## Access Compliance Report Public Rights-of-Way (Curb Ramps)

Intersection ID: 45542 Main Street: HARRIER\_RD Cross Street: GOSHAWK\_LN Location: SW

ADA ID: D6FD371F71C4 Ramp Type: PerpDiag Initial Pass/Fail: Fail Overall Compliance: No Severity Score: 21.25

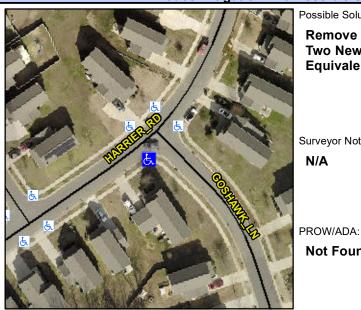
Not Found, R304.5.1, R304.2.2

Comp	oliance Description	Data	Comp	liance Description	Data
N/A	Ramp Length (in)	46.0	No	Ramp Slope (%)	11.6
No	Ramp Width (in)	47.5	Yes	Ramp XSlope (%)	1.3
N/A	Flare Type LT	N/A	N/A	Flare Type RT	N/A
N/A	Flare Slope LT (%)	N/A	N/A	Flare Slope RT (%)	N/A
N/A	Flare Traversable LT?	N/A	N/A	Flare Traversable RT?	N/A
N/A	Landing Length (in)	N/A	N/A	DWS Provided?	N/A
N/A	Landing Width (in)	N/A	N/A	DWS Contrast?	N/A
N/A	Landing Slope (%)	N/A	N/A	DWS Length (in)	N/A
N/A	Landing X Slope (%)	N/A	N/A	DWS Full Width?	N/A
N/A	Landing Curb? (Y/N)	N/A	N/A	DWS Offset (in)	N/A
N/A	Shared Landing?	N/A			
N/A	Gutter Ponding?	N/A	N/A	Gutter Slope (%)	N/A
N/A	Gutter Lip Ht (in)	N/A	N/A	Gutter X Slope (%)	N/A
N/A	Painted X Walk1?	No	N/A	Painted X Walk2?	No
	X Walk 1 Direction	To E		X Walk 2 Direction	To N
N/A	X Walk 1 Width (in)	N/A	N/A	X Walk 2 Width (in)	N/A
	X Walk 1 Slope (%)	0.5		X Walk 2 Slope (%)	0.1
	X Walk 1 X Slope (%)	3.1		X Walk 2 X Slope (%)	3.8

Remove & Replace Curb Ramp With
Two New Directional Ramps or
Equivalent.
